ENGINE - ENGINE H.P. COMPRESSOR INTRODUCTION OF WEIGHT REDUCED REAR OUTER CASE -
CATEGORY CODE 7 - MOD.ENG-72-0025

V2500-ENG-72-0025

Figure 1

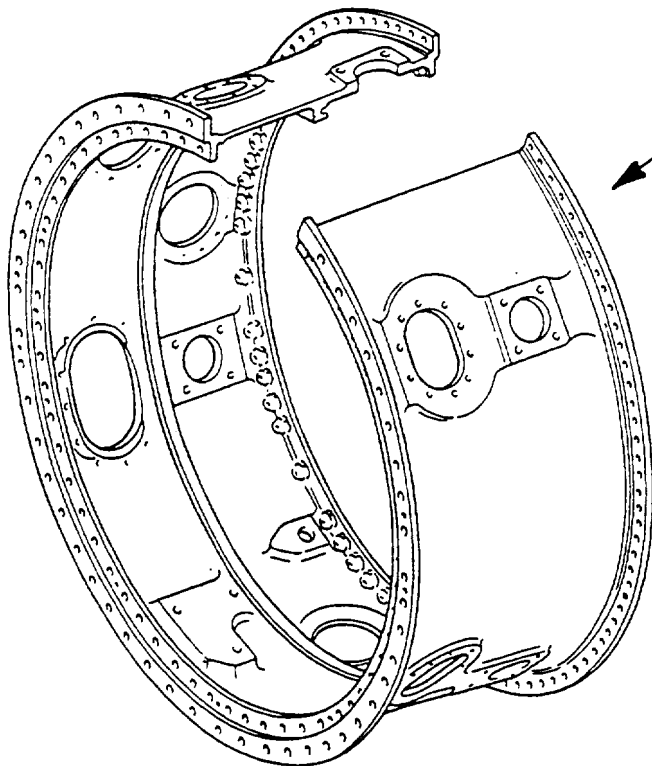
- (a) The stage 7 air bleed valve mounting boss is deleted together with the blanking plate and its retaining bolts.
- (b) The profile of the stage 7 and stage 11 boroscopic access bosses has been reduced by electro-chemical machining.
- (c) The profile of the 5 turbine walling air off-take bosses has been reduced by electro-chemical machining.

REMOVE 6A2949 H.P.COMPRESSOR
REAR OUTER CASE ASSEMBLY.
INSTALL 6A3557 H.P.COMPRESSOR
REAR OUTER CASE ASSEMBLY.

- (1) The new 6A3557 H.P. Compressor rear outer case assembly is interchangeable with in use use H.P. Compressor rear outer case assemblies.
- (2) Assemble new 6A3557 H.P. Compressor rear outer case assembly by use of approved procedures, Engine Manual, 72-41-00, Assembly.
